**RE: Bonanza #5-30-9-25
Application for Permit to Drill**

APPLICATION FOR PERMIT TO DRILL				5. MINERAL LEASE NO: ML-45560	6. SURFACE: State
1A. TYPE OF WORK: DRILL <input checked="" type="checkbox"/> REENTER <input type="checkbox"/> DEEPEN <input type="checkbox"/>				7. IF INDIAN, ALLOTTEE OR TRIBE NAME:

**WORKSHEET
APPLICATION FOR PERMIT TO DRILL**

LOCATION LAYOUT FOR
 BONANZA #5-30-9-25
 SECTION 30, T9S, R25E, S.L.B.&M.
 2166' FNL 650' FWL

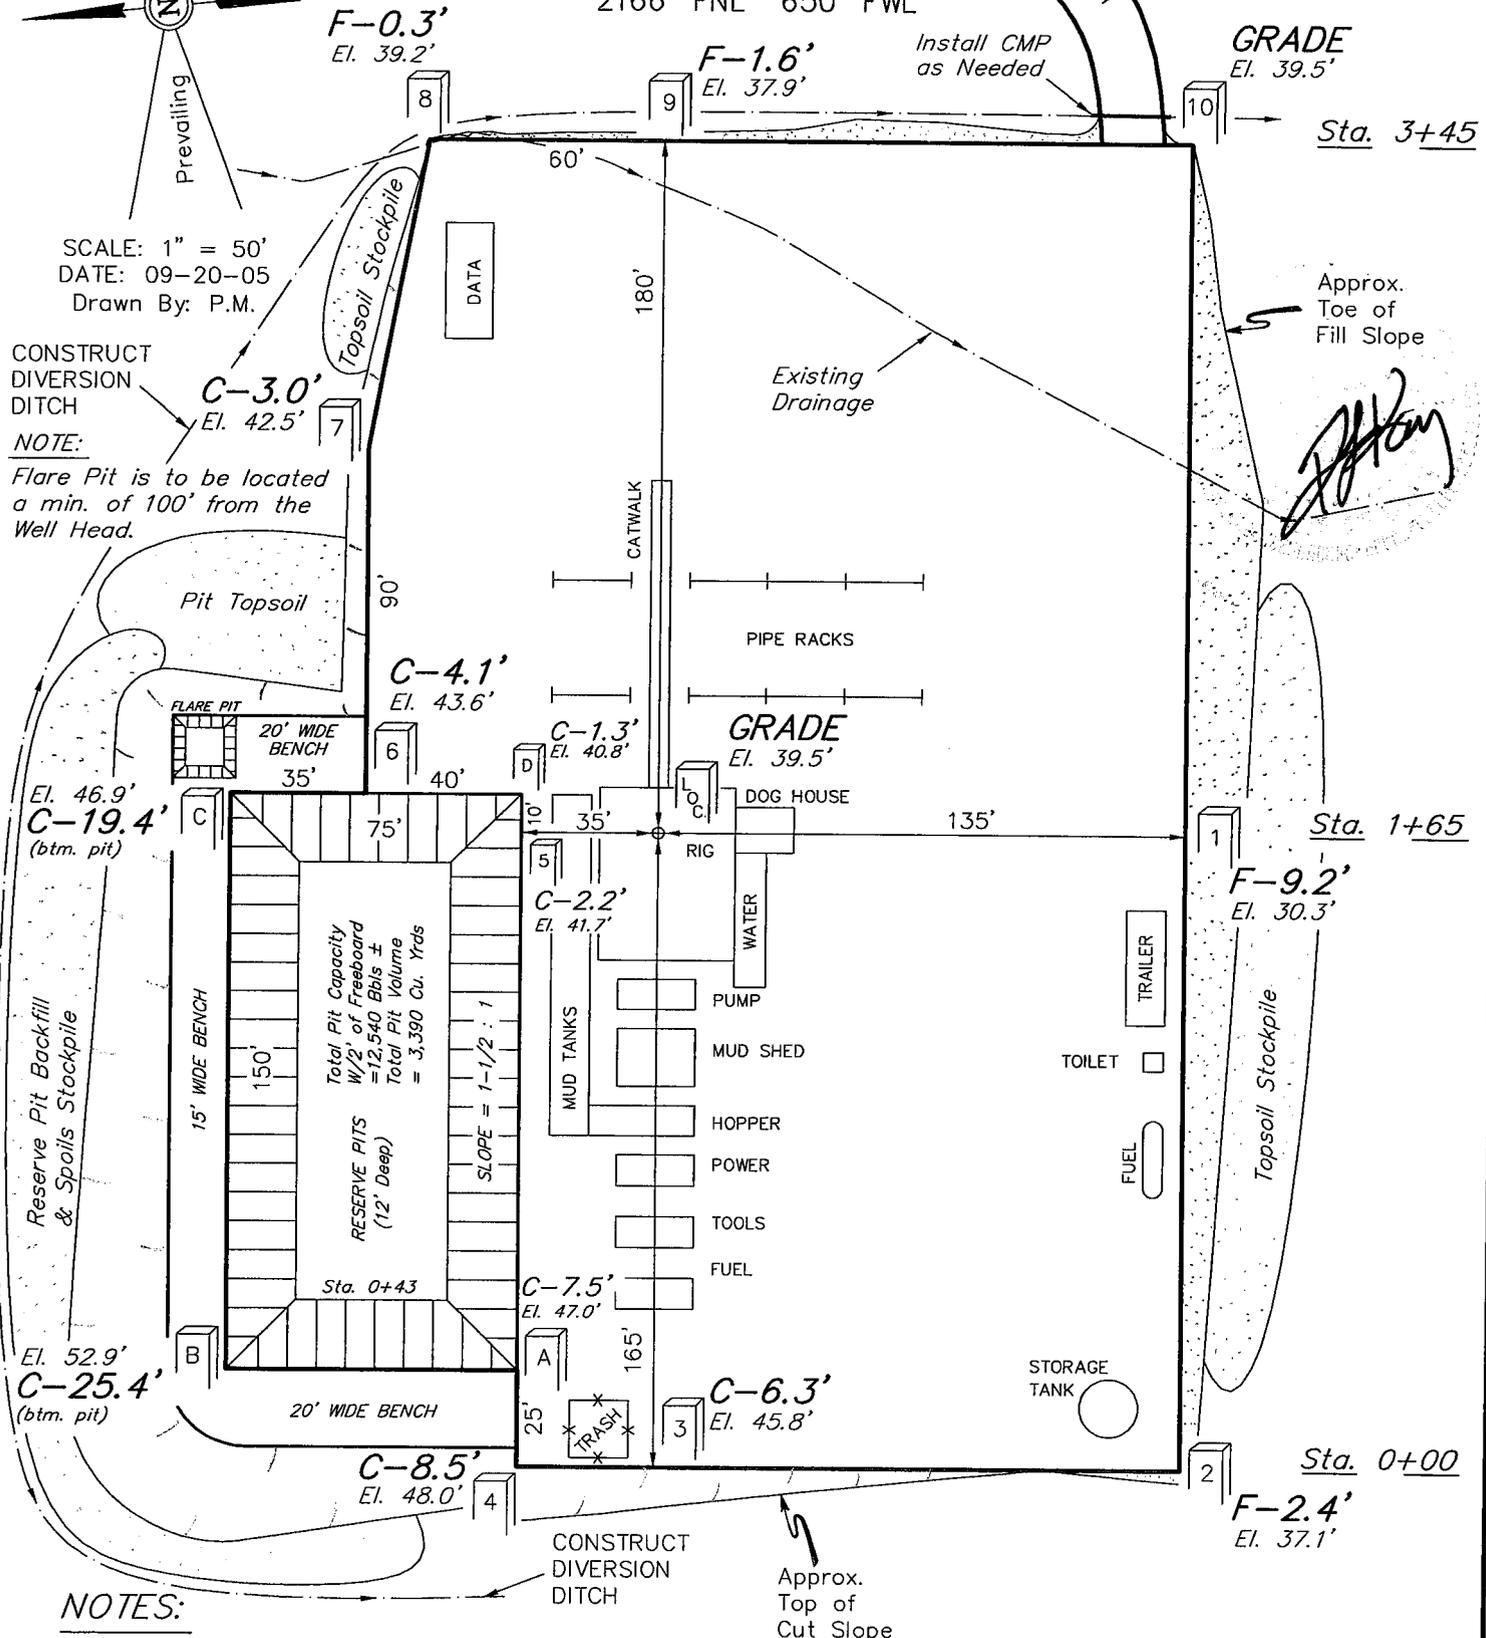
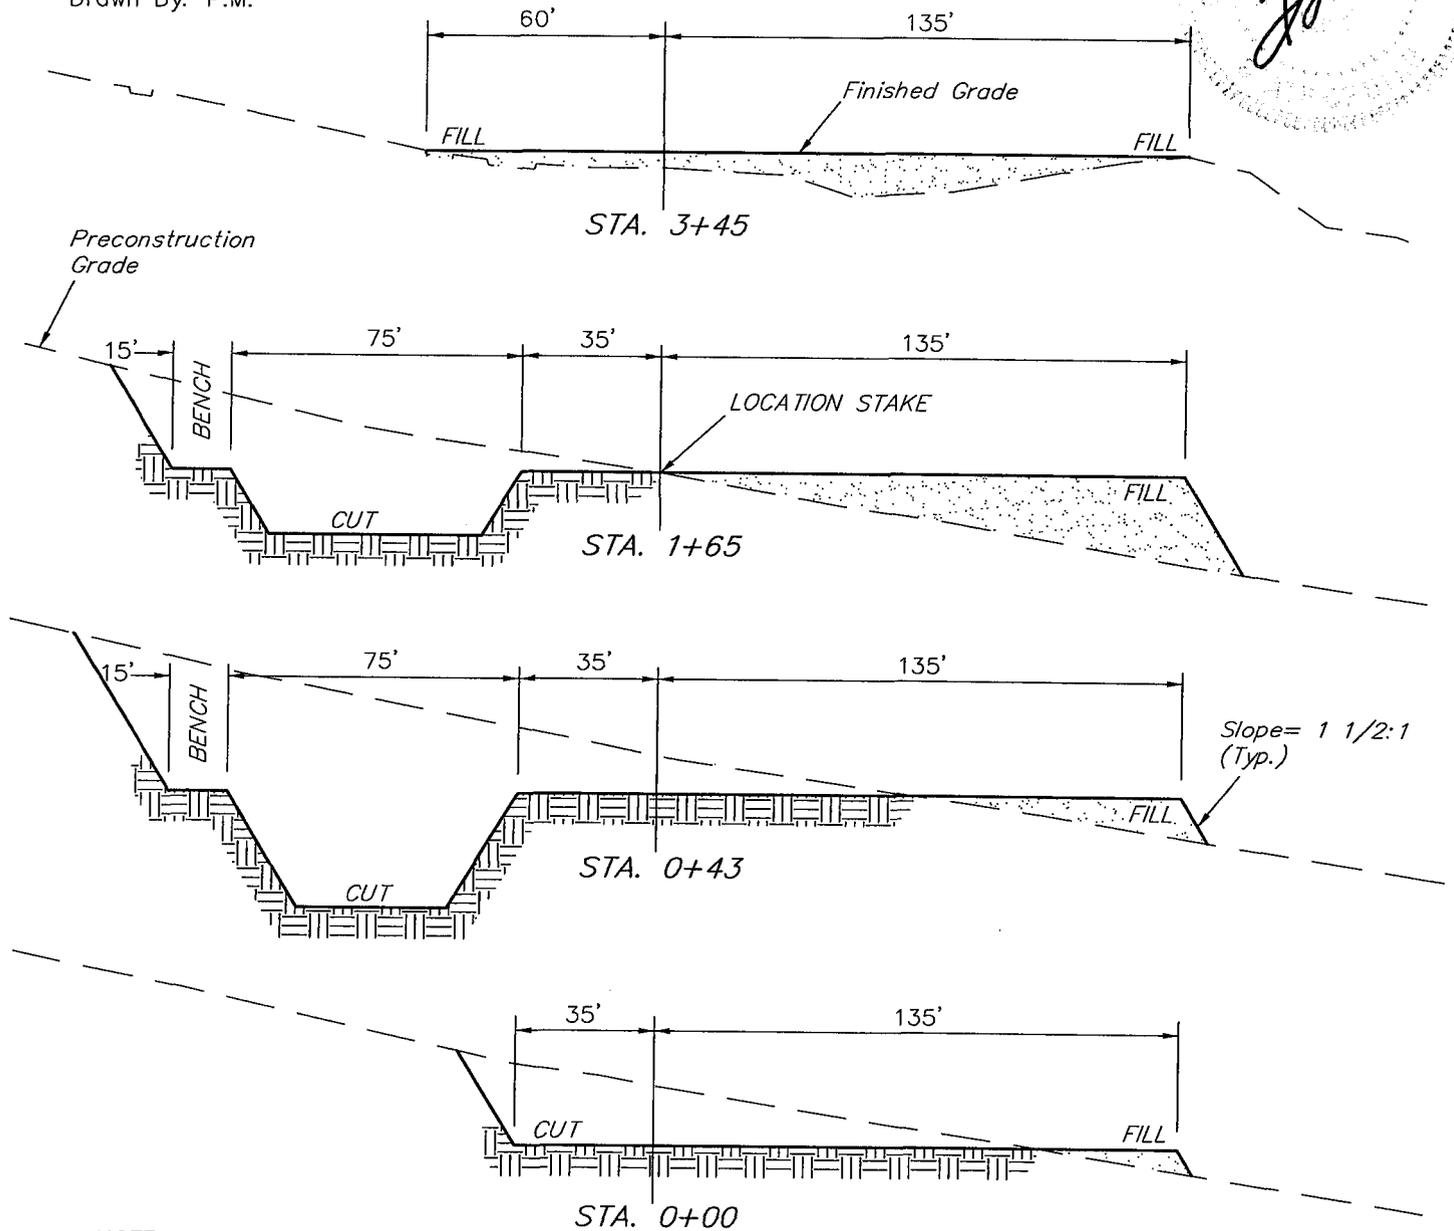
1. A synthetic liner with a minimum thickness of 16 mils with a felt subliner shall be properly installed and maintained in the reserve pit.
2. Location will be rotated counter-clockwise 45 degrees to provide added protection to a buried pipeline north of the site.
